## Product Change Notice (PCN)

PCN Number: **PCN-0451141R-01**

Product(s) Affected: PJ-035D

PREVIOUS CUI DEVICES DETAIL / IMAGE	NEW CUI DEVICES DETAIL / IMAGE

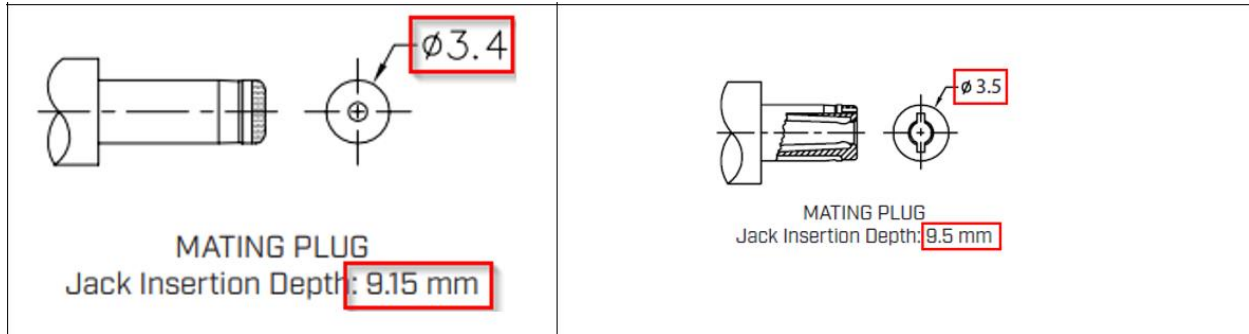
Description of Change: mechanical, and material differences as shown below:

<p>PCB LAYOUT TOP VIEW</p>	 <p>Recommended PCB Layout Top View</p>																																							
<table border="1"> <thead> <tr> <th></th> <th>MATERIAL</th> <th>PLATING</th> </tr> </thead> <tbody> <tr> <td>center pin</td> <td><b>copper</b></td> <td>nickel</td> </tr> <tr> <td>terminal 1</td> <td>brass</td> <td>tin</td> </tr> <tr> <td>terminal 2</td> <td><b>copper alloy</b></td> <td>tin</td> </tr> <tr> <td>terminal 3</td> <td>brass</td> <td>tin</td> </tr> <tr> <td>plastic</td> <td>PBT</td> <td></td> </tr> </tbody> </table>		MATERIAL	PLATING	center pin	<b>copper</b>	nickel	terminal 1	brass	tin	terminal 2	<b>copper alloy</b>	tin	terminal 3	brass	tin	plastic	PBT		<table border="1"> <thead> <tr> <th>DESCRIPTION</th> <th>MATERIAL</th> <th>PLATING/COLOR</th> </tr> </thead> <tbody> <tr> <td>center pin</td> <td><b>brass</b></td> <td>nickel</td> </tr> <tr> <td>terminal 1</td> <td>brass</td> <td>tin</td> </tr> <tr> <td>terminal 2</td> <td><b>bronze</b></td> <td>tin</td> </tr> <tr> <td>terminal 3</td> <td>brass</td> <td>tin</td> </tr> <tr> <td>cover</td> <td>PBT [UL94V-0]</td> <td>black</td> </tr> <tr> <td>housing</td> <td>PBT [UL94V-0]</td> <td>black</td> </tr> </tbody> </table>	DESCRIPTION	MATERIAL	PLATING/COLOR	center pin	<b>brass</b>	nickel	terminal 1	brass	tin	terminal 2	<b>bronze</b>	tin	terminal 3	brass	tin	cover	PBT [UL94V-0]	black	housing	PBT [UL94V-0]	black

MATERIAL	PLATING																																						
center pin	<b>copper</b>	nickel																																						
terminal 1	brass	tin																																						
terminal 2	<b>copper alloy</b>	tin																																						
terminal 3	brass	tin																																						
plastic	PBT																																							
DESCRIPTION	MATERIAL	PLATING/COLOR																																						
center pin	<b>brass</b>	nickel																																						
terminal 1	brass	tin																																						
terminal 2	<b>bronze</b>	tin																																						
terminal 3	brass	tin																																						
cover	PBT [UL94V-0]	black																																						
housing	PBT [UL94V-0]	black
